**ADDENDUM NO. 2**  
**February 7<sup>th</sup>, 2025**

**PROJECT: TRI-TRY WSC**  
**PUMP STATION IMPROVEMENTS**

**BID DATE: February 12<sup>th</sup>, 2025**

**ASPERMONT, TEXAS**  
**TRI-TRY WATER SYSTEM IMPROVEMENTS**  
**BUILDING LAYOUT**

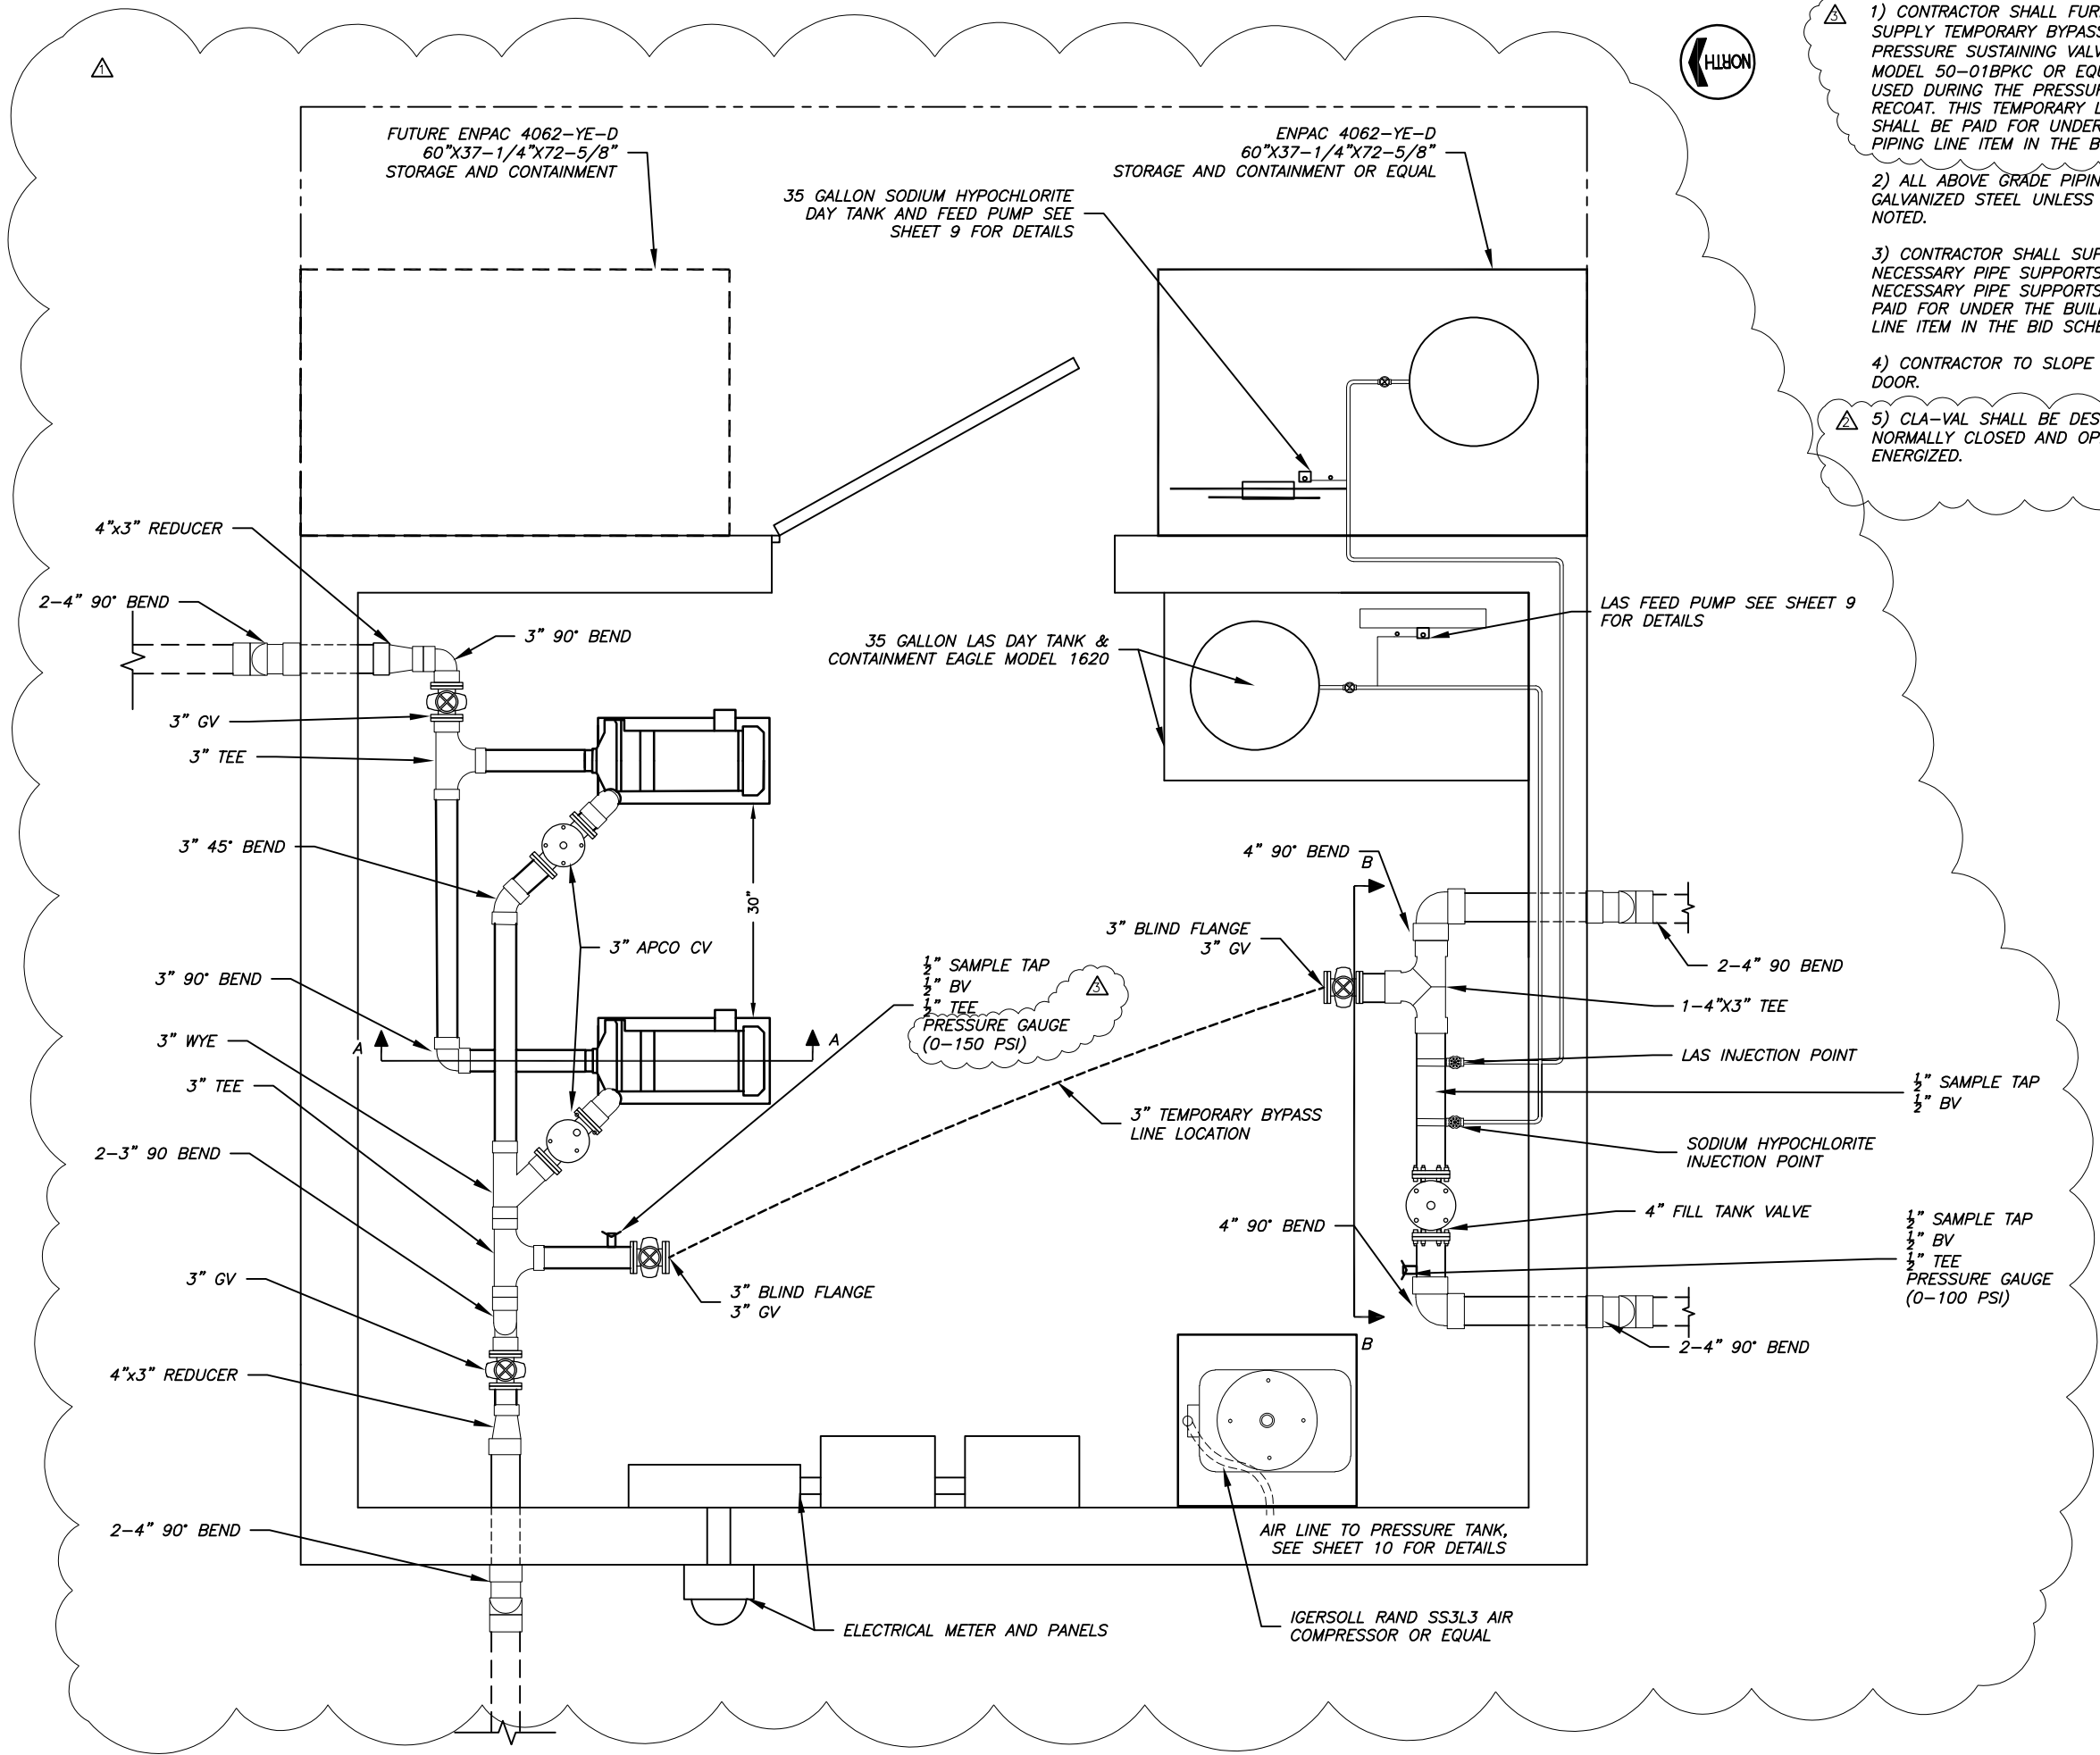
Sheet 6 – Building Layout – This sheet has been modified to change the pressure range on the pressure gauge located on the downstream of the booster pumps and provide clarification on the temporary pressure sustaining bypass valve.

- NOTE:**
- 1) CONTRACTOR SHALL FURNISH AND SUPPLY TEMPORARY BYPASS LINE AND 3" PRESSURE SUSTAINING VALVE (CLA-VAL MODEL 50-01BPKC OR EQUAL) TO BE USED DURING THE PRESSURE TANK RECOAT. THIS TEMPORARY LINE AND VALVE SHALL BE PAID FOR UNDER THE BUILDING PIPING LINE ITEM IN THE BID SCHEDULE.
  - 2) ALL ABOVE GRADE PIPING SHALL BE GALVANIZED STEEL UNLESS OTHERWISE NOTED.
  - 3) CONTRACTOR SHALL SUPPLY ALL NECESSARY PIPE SUPPORTS FOR PROJECT. NECESSARY PIPE SUPPORTS SHALL BE PAID FOR UNDER THE BUILDING PIPING LINE ITEM IN THE BID SCHEDULE.
  - 4) CONTRACTOR TO SLOPE FLOOR TO DOOR.
  - 5) CLA-VAL SHALL BE DESIGNED TO BE NORMALLY CLOSED AND OPEN WHEN ENERGIZED.
